i Should it be necessary to install a new oil filter (e.g. at an oil change or in the event of severe contamination), only the oil filter with the part number **A 221 277 00 95** should still be used with immediate effect.

Picture 2

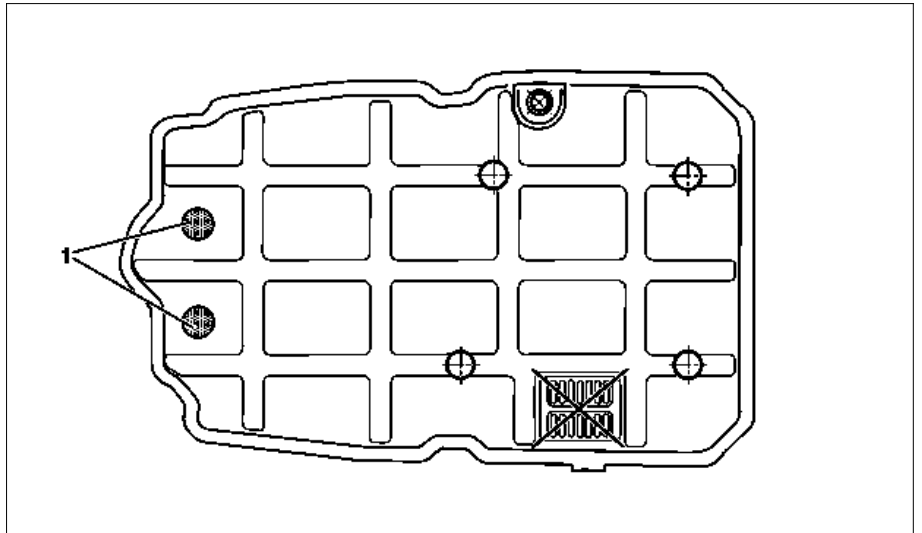
Observe positioning of the 2 magnets (see picture 2).

Observe positioning of the 2 magnets (see picture 2).

If the grid magnet (A 220 271 00 98) is installed, it must be replaced by 2 magnets A 000 988 01 52.

Picture 3

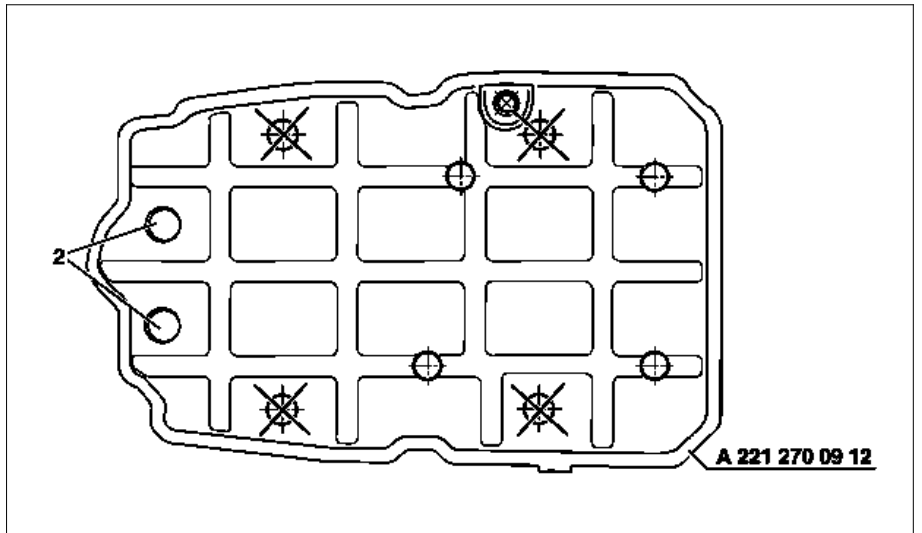
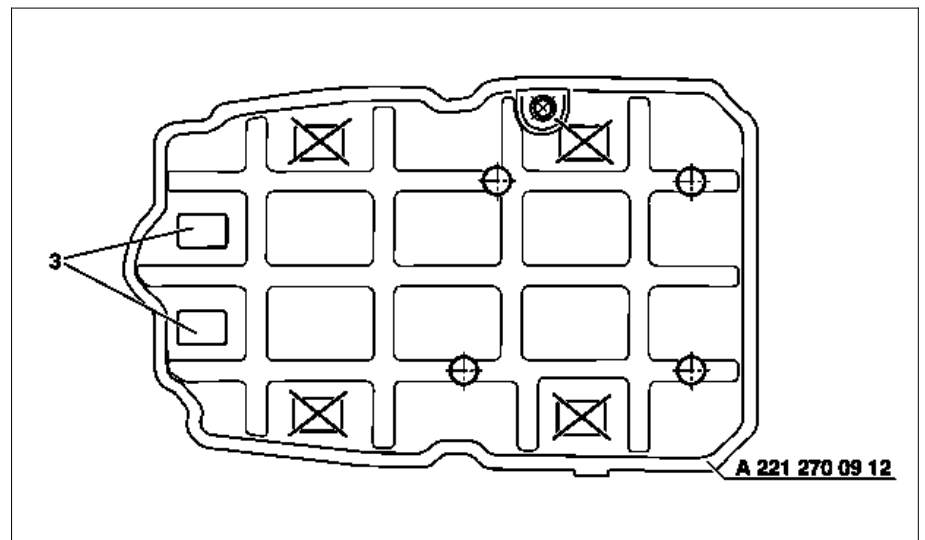
If 6 magnets (round or rectangular) are installed, 4 must be removed and the other 2 positioned as in picture 3 and 4.
